DEVELOPMENT ASSESSMENT REPORT

<b>Application No.</b>	DA201800055
<b>Address</b>	112-116 Parramatta Road, Stanmore
<b>Proposal</b>	To demolish existing improvements and construct a 5 storey mixed use building containing a shop and 35 boarding rooms including a managers room with associated car parking.
<b>Date of Lodgement</b>	31 May 2018
<b>Applicant</b>	Environa Studio
<b>Owner</b>	Angela Lepouris and Claude Cipolla
<b>Number of Submissions</b>	5
<b>Value of works</b>	\$5,458,085.00
<b>Reason for determination at Planning Panel</b>	Departure from Building Height and FSR development standards exceed officer delegation
<b>Main Issues</b>	Car parking
<b>Recommendation</b>	Consent subject to conditions
<b>Attachment A</b>	Recommended Conditions of consent
<b>Attachment B</b>	Plans of proposed development
<b>Attachment C</b>	Plan of Management
<b>Attachment D</b>	Clause 4.6 Variation

*Image 5: Eastern Side Elevation Showing maximum encroachment into rear massing controls*

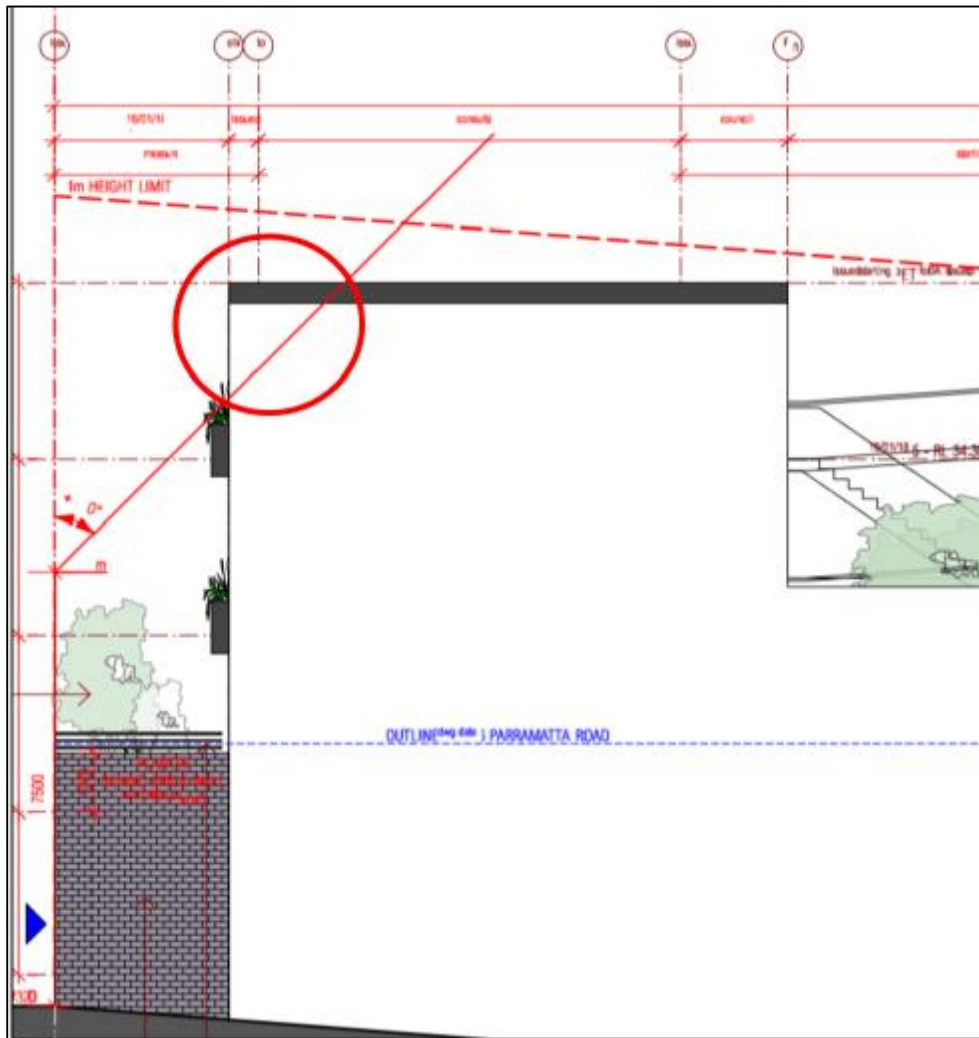
- i. The rear building envelope must be contained within the combination of the rear boundary plane and a 45 degree sloping plane from a point 7.5 metres vertically above the lane ground level, measured at the rear boundary, and contain a maximum of two storeys on the rear most building plane;*
- ii. Notwithstanding point i., building envelopes may exceed the above building envelope control where it can be demonstrated that any rear massing that penetrates above the envelope control will not cause significant visual bulk or amenity impacts on neighbouring properties to the rear;*
- iii. The rear building envelope must contribute positively to the visual amenity of the laneway, and encourage rear lane activation through measures such as providing appropriate lighting and opportunities for passive surveillance.”*

The rear massing is consistent with the existing streetscape rear boundary setback and a 45 degree sloping plane from a point 7.5 metres vertically above the ground level with the exception of the southern corner of level 5 shown in Image 5 below. The minor intrusion into the sloping plane is proposed at level 5 at the southern-most corner of the building. In this instance the slight variation is considered acceptable as it results in a consistent rear alignment of the upper levels, rather than a setback for level 5 which would result in a tiered ‘wedding cake’ effect and an inconsistent roof form. The variation does not result in any

privacy or amenity impacts as these boarding room windows service the bathrooms and kitchenette area of the rooms. There are no balconies proposed on levels 4 or 5 of the laneway elevation. Similarly, compliance with the rear massing controls would not result in reduced solar access given the setback of the level to the boundary.

Extract from the West Elevation showing the Level 5 roof non-compliance (measured from natural ground level below)

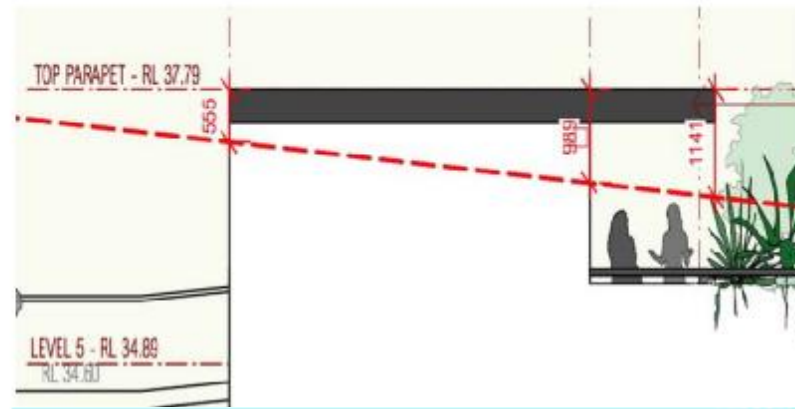
Based on an extrapolated ground level the development requires a minor variation to the MLEP height of buildings development standard as the lift core exceeds the 14-metre height control by 1.995 metres on the southern side to 2.189 metres on the northern side as shown in Figure 2. The northern edge of the roof over Level 5 on the northern side of the courtyard exceeds the height limit by up to 630mm on the western side of Level 5 to 1.141 metres on the eastern side of Level 5 as shown in Figures 3 and 4 respectively.
